HOWARD COUNTY HEALTH DEPARTMENT  
BUREAU OF ENVIRONMENTAL HEALTH  
WELL & SEPTIC PROGRAM  
TEL: (410)313-1771 FAX: (410)313-2648

Information Form for the Installation of the Well Pump, Pitless Adapter, and Supply Piping

SITE INSPECTION SHEET

OWNER: ~~THOMAS~~ THOMAS KRUNKAITIS PHONE #: 410 686 2701 (contractor)  
ADDRESS: 1563 Old Annapolis RD CONTRACTOR: ELITE POOLS  
WOODBINE, MD 21237 WELL TAG #: HO-94-3113  
SUBDIVISION: N/A LOT: N/A COUNTY #: (XIII)  
PROPOSAL: RELOCATE WELL LINE FOR POOL (PROPOSED)

LOCATION DIAGRAM

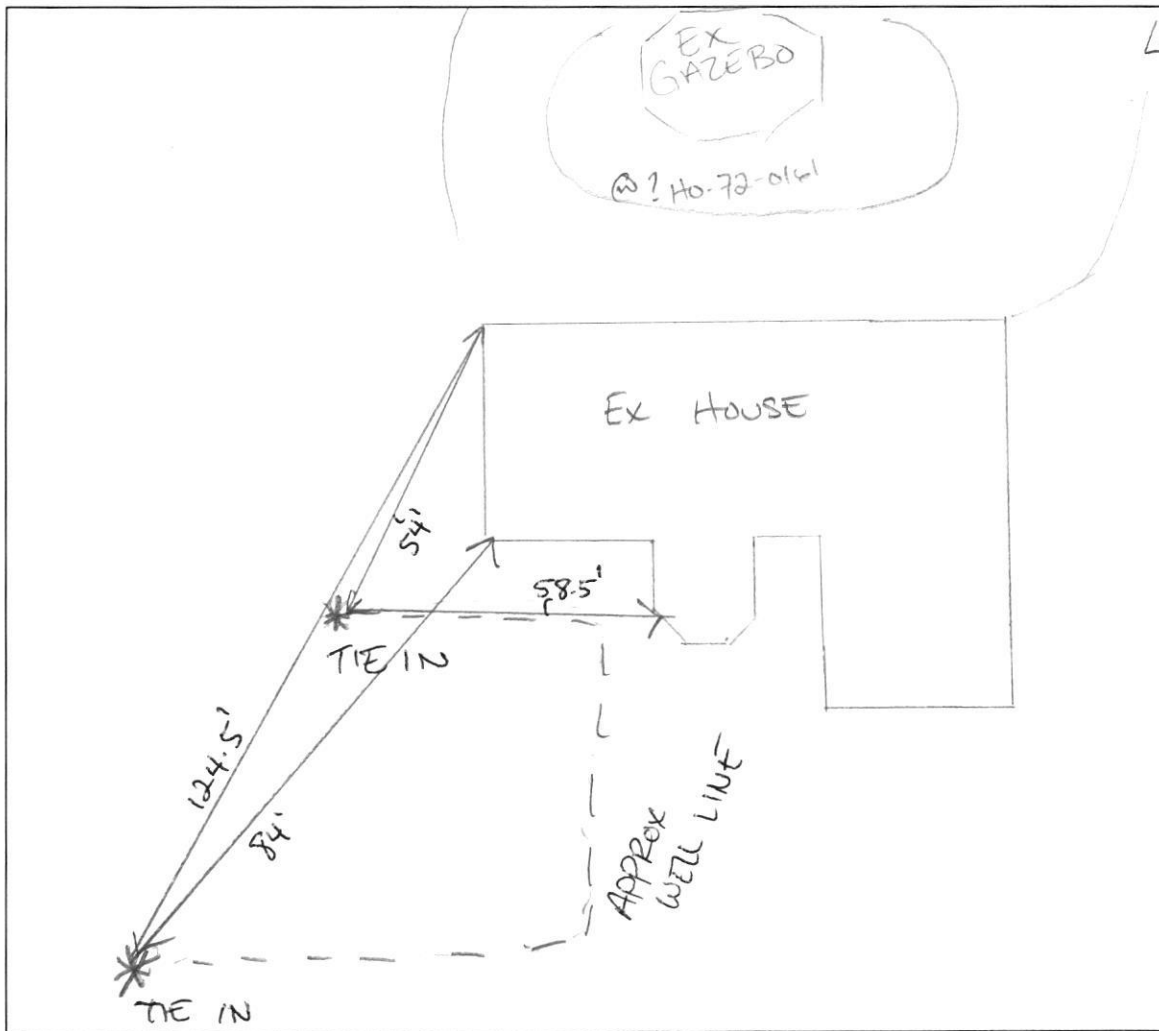
Pipe was recently rerouted - SEE ATTACHED S.I. DIAGRAM  
6/20/2018

40-94 COMMENTS: 6/20/2018 Unable to locate Ho-72-0161. HAND  
3113 PUMP OUT FRONT. WILL PASS. MEETS DEPTH REQ

WELL LINE HAS TRACE WIRE

LOCATION DIAGRAM

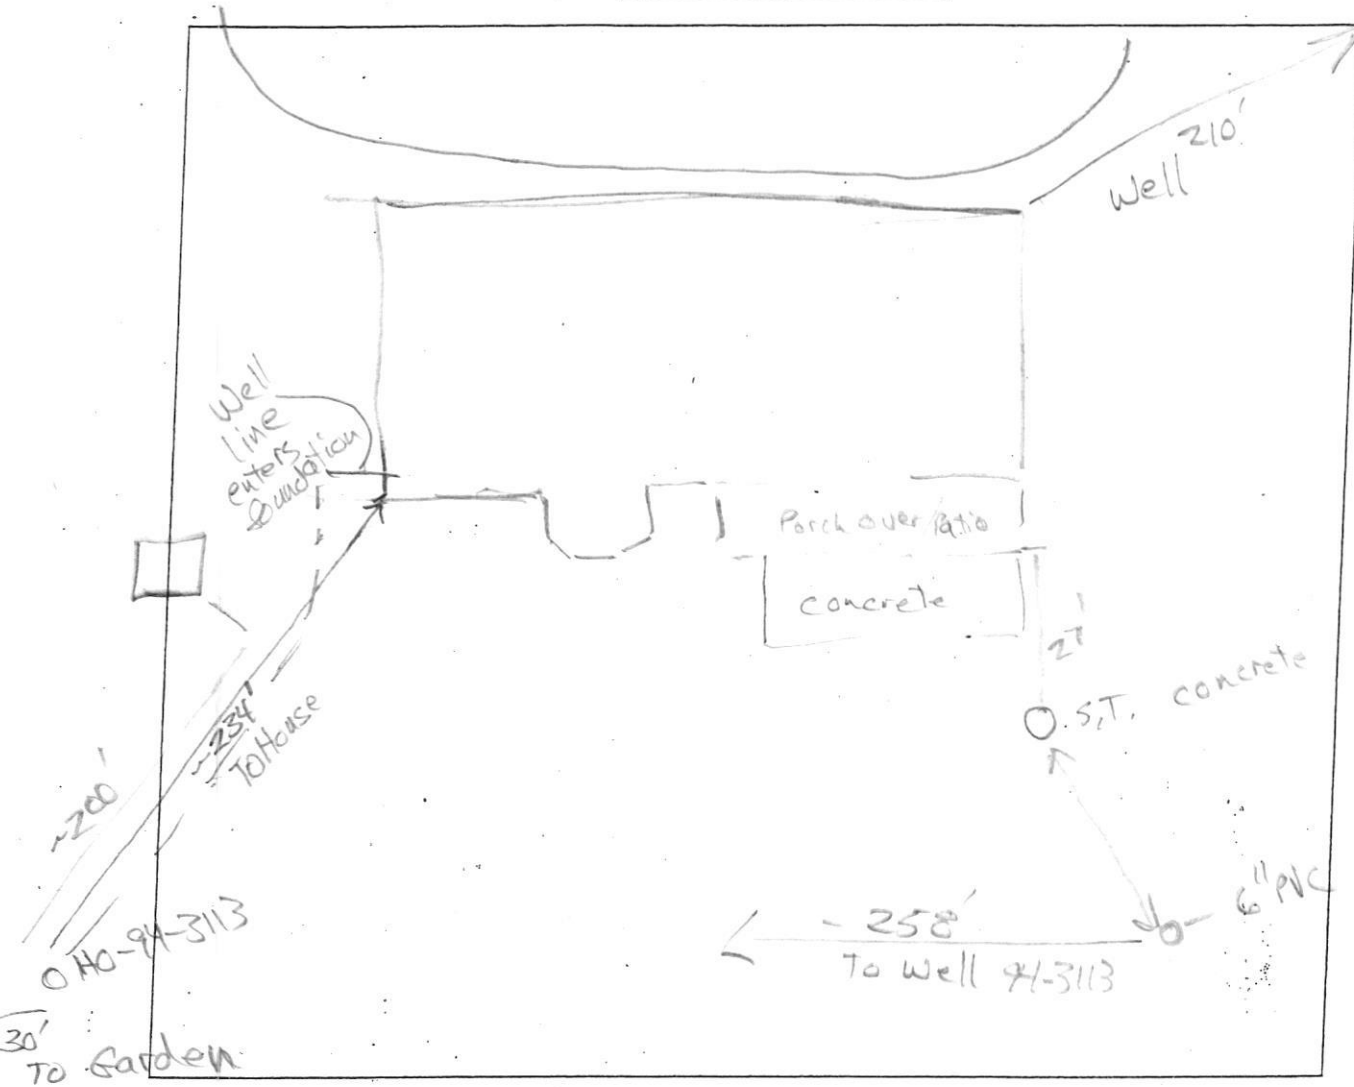
Well line must be re-located prior to pool excavation.

COMMENTS: Wood Ashes (charcoal) around S.T. access cover.

A 1.5" PVC pipe is next to Dry Well cleanout (6" PVC), and rises to about 2' above soil surface. IT is open and terminates at elevation lower than septic tank
